## IDAP REPORT

<b>Property:</b>	42 Barker Road, Strathfield Lot A in DP 313710 DA2021/172
<b>Proposal:</b>	Demolition of existing structures, construction of a two-storey dwelling house with a basement and in-ground swimming pool.
<b>Applicant:</b>	C Baini
<b>Owner:</b>	M P & G A Amcha
<b>Date of lodgement:</b>	6 August 2021
<b>Notification period:</b>	20th August 2021 to 6th September 2021
<b>Submissions received:</b>	Zero (0)
<b>Assessment officer:</b>	L Fanayan
<b>Estimated cost of works:</b>	\$2,076,140.00
<b>Zoning:</b>	R2-Low Density Residential - SLEP 2012
<b>Heritage:</b>	No
<b>Flood affected:</b>	Yes
<b>Is a Clause 4.6 Variation Proposed:</b>	No
<b>RECOMMENDATION OF OFFICER:</b>	<b>APPROVAL</b>

Figure 12: Cross section showing ground floor, first floor and void space ceiling heights.

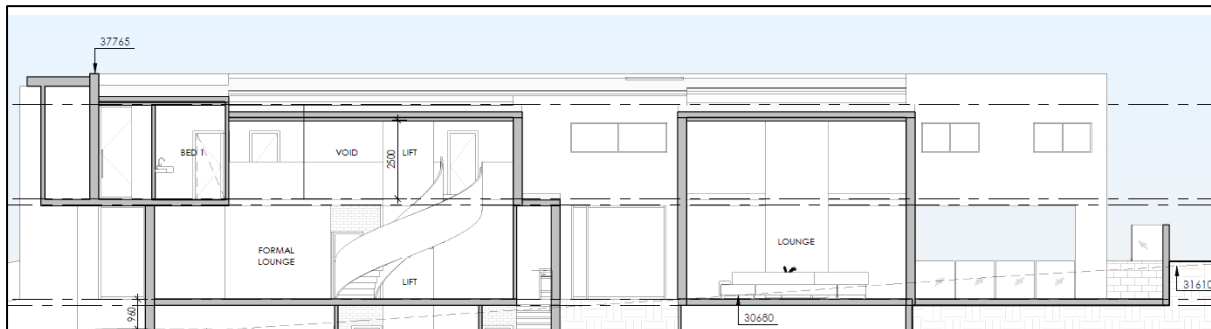
The proposed ceiling height for the ground floor is 3.2m and although exceeds the development control it does not exacerbate bulk and scale nor does it create any non-compliance with overall building height. In certain rooms the ceiling height will be 5.7m due to the effect of voids and no further effect on bulk and scale of the dwelling to the streetscape. On balance, the larger ceiling height of the ground floor is acceptable.

The void spaces included in the first floor of the design are large however the applicant has agreed to reduce the roof height over the voids. Amended plans show the roof over both void areas have been reduced, resulting in a void height of 2.5m on top of the ground level ceiling height to attain a maximum height of 5.7m.

To ensure that the void space above the formal dining room remains a void an ongoing condition will be included in the consent.

Figure 13: Void spaces above to the stairwell, foyer and living room.

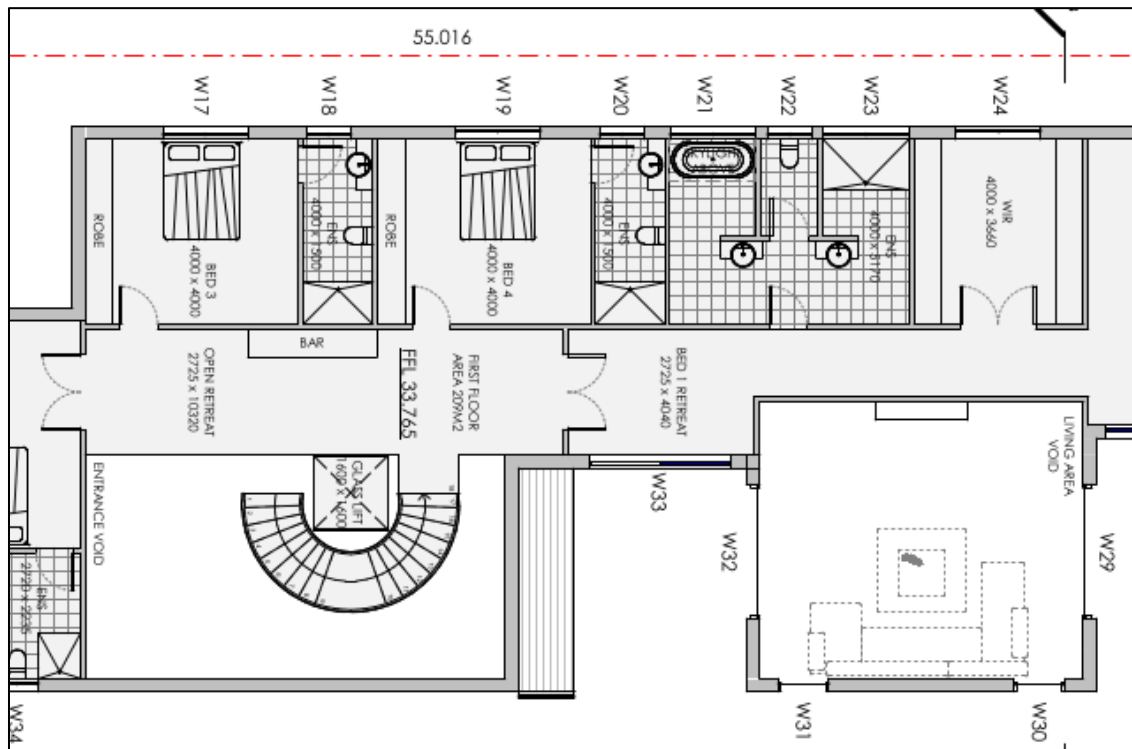
These voids relate to the stairwell, formal lounge and living spaces (refer to Figure 13).
